DOCUMENT CHANGE REQUEST

DCR number 372 Changes required for: General

Title: Transistors High Power NPN, based on types 2N3439 and 2N3440

Number: 5203/011

1.5 **MAXIMUM RATINGS**

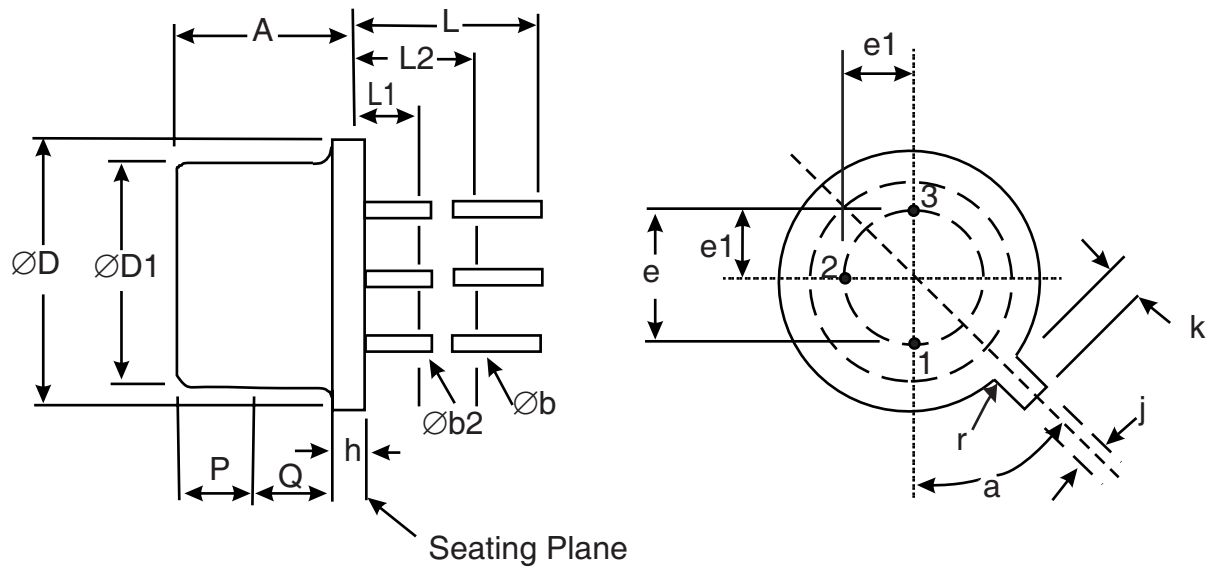
5. Deletion of obsolete Variants 09 to 14 from the available range (not supported by either STMicroelectronics or Semelab).
6. Figure 1(a) Parameter Derating Information moved to be a note (Note 1) in the Maximum Ratings table.

1. For T_{amb} or $T_{case} > +25^{\circ}C$, derate linearly to 0W at +200 $^{\circ}C$.
2. For Variants with tin-lead plating or hot solder dip lead finish all testing performed at $T_{amb} > +125^{\circ}C$ shall be carried out in a 100% inert atmosphere.
3. Duration 10 seconds maximum at a distance of not less than 1.5mm from the device body and the same lead shall not be resoldered until 3 minutes have elapsed.

1.6.2 Metal Can Package (TO-39) - 3 lead

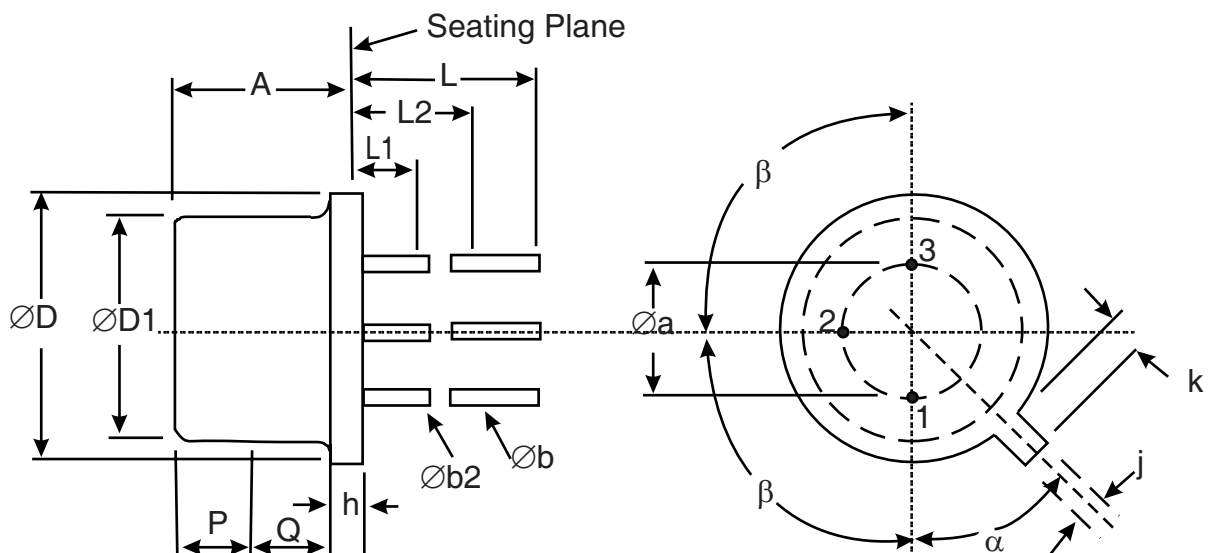
7. Para. 4.3.2 Weight requirements moved to Component Type Variants table.
8. Figure 2 re-named "Physical Dimensions and Terminal Identification"; Figure 2(a) amended to reflect the TO-5 package currently supplied; Figure 2(b) amended to reflect the TO-39 package currently supplied.

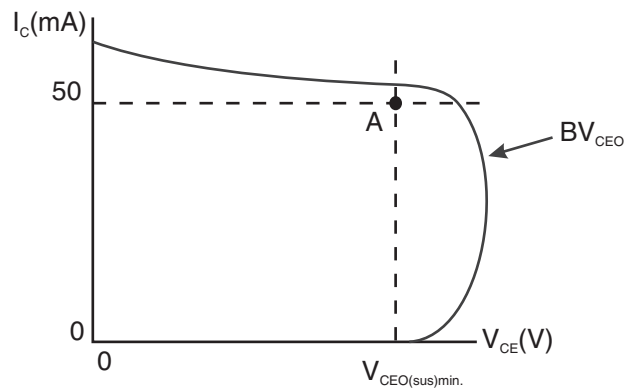
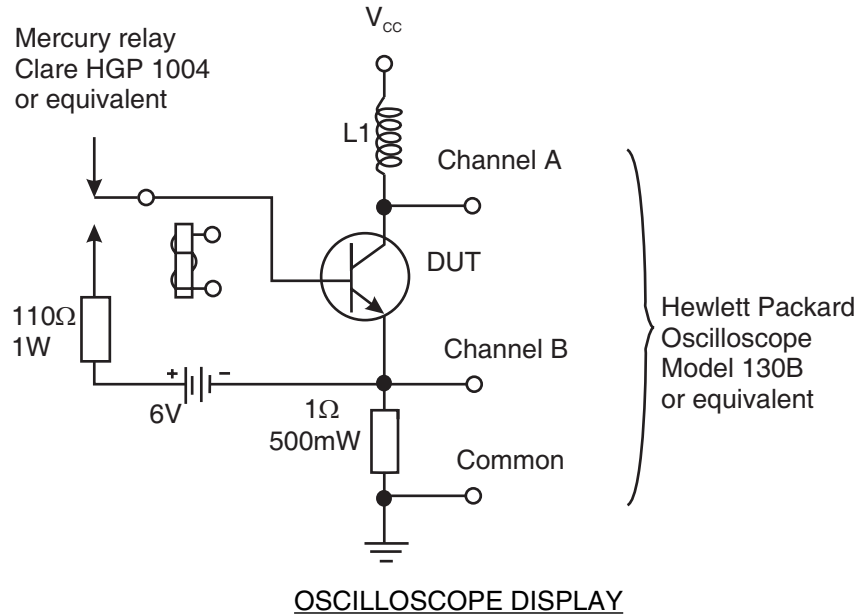
23. Tables 2, 3 and 4 - Test Conditions column: addition of Test, or Bias, Conditions for referenced MIL-STD-750 Test Methods as and where applicable.
24. Figure 4 amended and moved to be a note (Note 4) to Room Temperature Electrical Measurements.

1. Pulsed measurement: Pulse Width $\leq 300\mu s$, Duty Cycle $\leq 2\%$.
2. Saturation voltage is measured 6mm from the case.
3. For AC characteristics read and record measurements shall be performed on a sample of 32 components with 0 failures allowed. Alternatively a 100% inspection may be performed.
4. $V_{CE(sus)}$ shall be measured using the test circuit shown below. $V_{CC} = 0V$ to 60V, pulsed, Pulse

Width $\leq 300\mu\text{s}$, Duty Cycle $\leq 2\%$. $I_{CC} = 100\text{mA}$. Inductor L1 shall have the following characteristics: $L = 25\text{mH}$, $Q = 76$, $R = 83.4\Omega$, $I = 75\text{mA}$.

BV_{CEO} is acceptable if the trace is both to the right of, and above, point A, as shown.
